Lighting recommendations for the Social Security Administration Frank Hagel Federal Building in Richmond CA

Final Report October 1999

Lighting Recommendations for the Social Security Administration Frank Hagel Federal Building

Figure 3. Illuminance distribution from indirect lighting system. Values calculated using Lumem Micro Version 6.0.

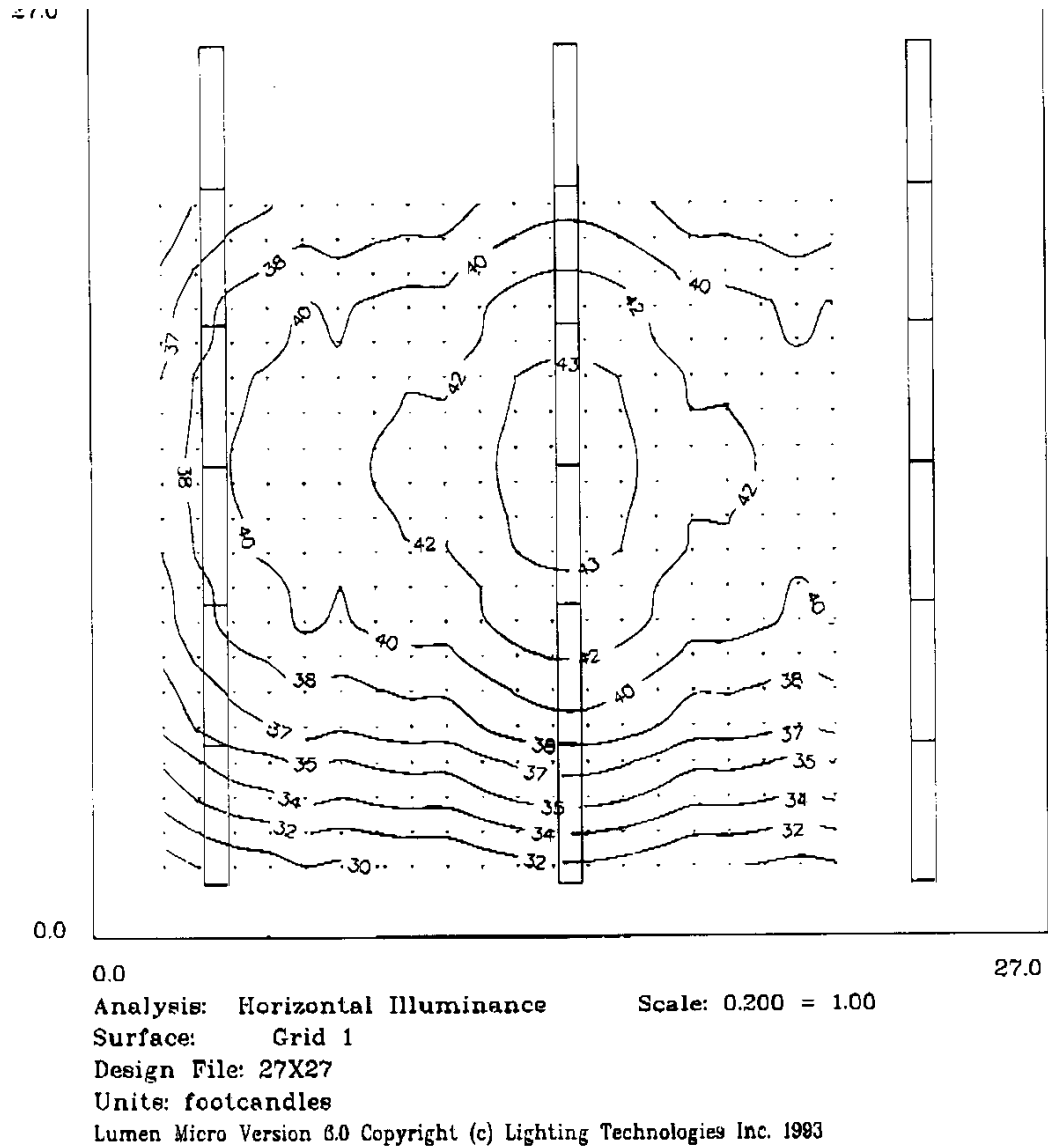
The specific indirect lighting solution that we recommend will use rows of indirect luminaires with only one lamp per 4 ft section. To provide more accurate information, we have selected a particular manufacturer (Finelite) and product (Series 1) for modeling the lighting impact of the indirect lighting system. Other manufacturers may have similar products with similar performance characteristics that would perform satisfactorily also. The technical specifications (in PDF format) for each of the recommended fixture types is given as an attachment to this report. (Use of a specific company name does not denote endorsement of this or any other product. See disclaimer at end of report).

The following assumptions were made in modeling the resulting light levels from the indirect lighting system:

Fixture type: 24' Finelite Series 1 fixture with EP reflector
Lamp: 1 T-8 per 4 ft. section, 2850 lumens
Ballast: 2-lamp electronic ballast with ballast factor = 1.25
Suspension length: 21 inches
Light maintenance factor: .75
Ceiling/wall/floor reflectances: 80/50/20

The results of the lighting analysis are:

Average illuminance: 38.7 footcandles
 Minimum: 28 footcandles
 Maximum: 44.1 footcandles

It should be noted that this solution requires a ballast with a high ballast factor (1.25) to obtain satisfactory light levels. Use of normal ballast factor will result in lower illumination levels. It should be noted that the above analysis does not include the effects of the partitions which will reduce the delivered light levels by about 20%.
